UNITED STATES  
NUCLEAR REGULATORY COMMISSION  
WASHINGTON, D. C. 20555

SUMMARY OF MEETING HELD ON JUNE 2, 1976 WITH REPRESENTATIVES OF THE  
MARK I OWNER'S GROUP

Subject: Draft Criteria for Computation of  
Structural Element Capacity (TRC-032)

—Variation in the strain-hardening exponent and yield strength with the tensile strength of typical pressure-vessel steels

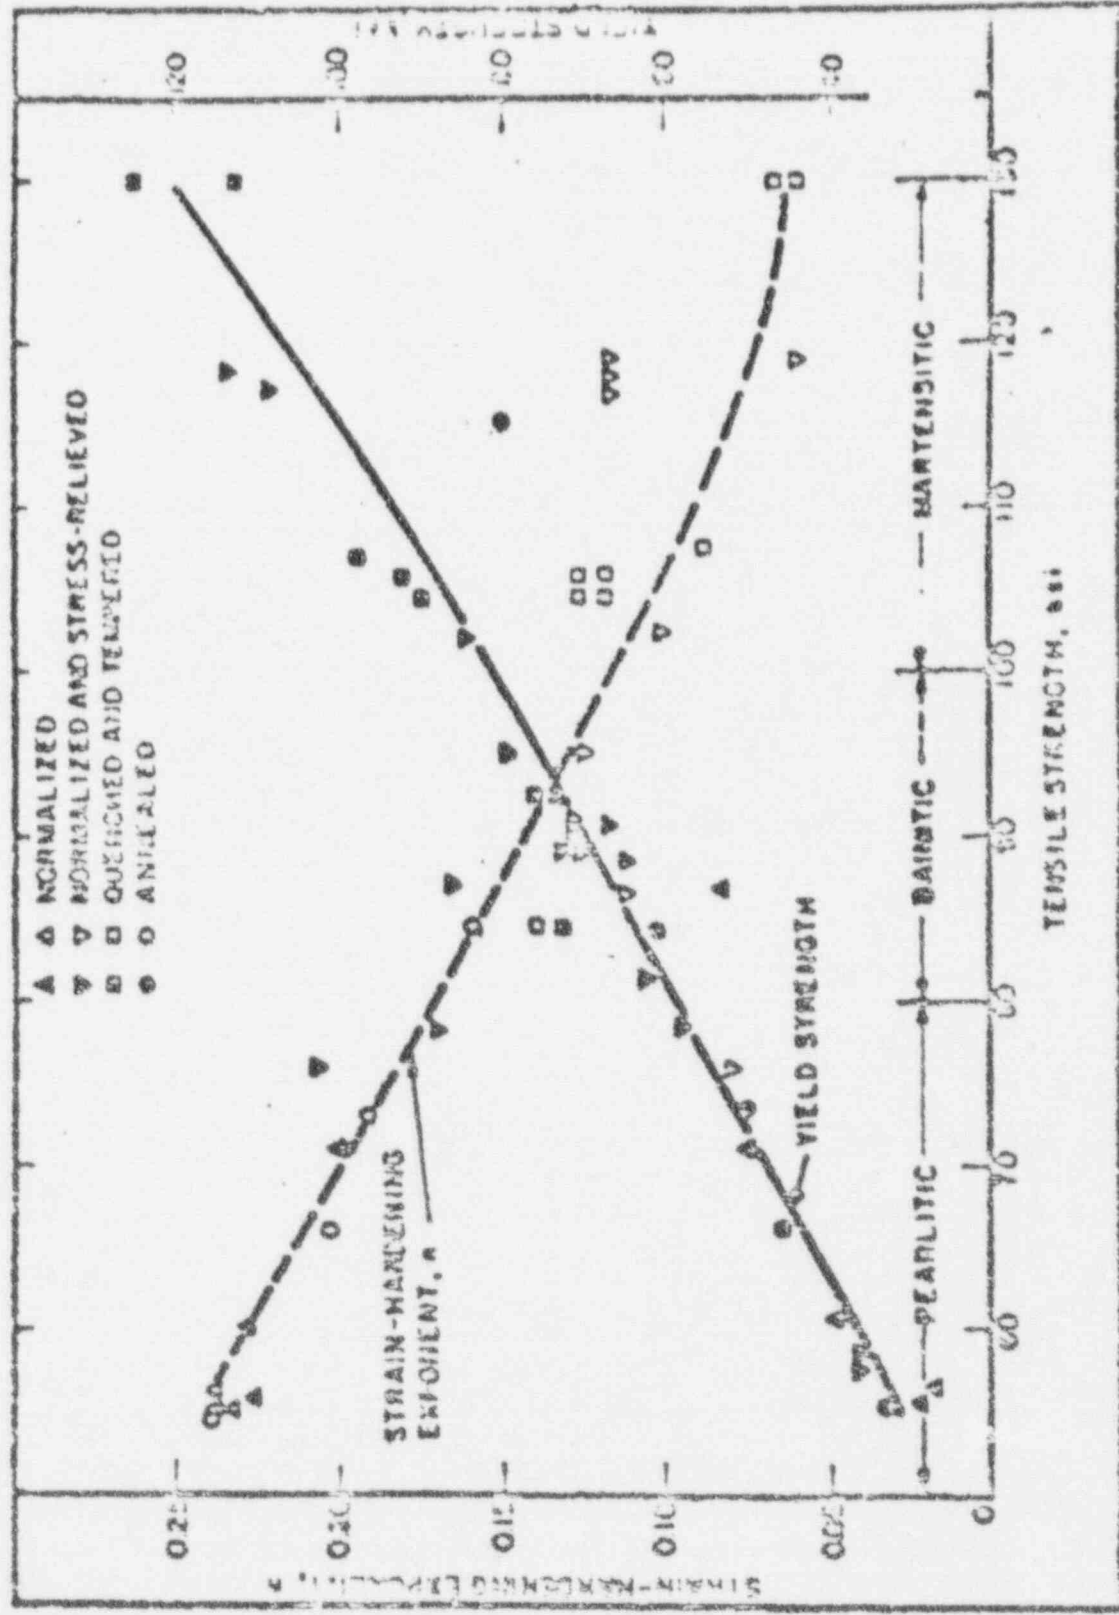
- b. The equation of the form  $S_y + (S_u - S_y)/3$  which appears five places in the lower half of Table F-1322.2-1 are developed to assure that the maximum strain does not exceed one-third of the uniform elongation of the material. This limit shall also be used as a strain limit in conjunction with F-1324.5. The uniform elongation may be taken as the strain hardening exponent given as a function of tensile strength by the attached figure which is taken from Welding Research Council Bulletin 101.
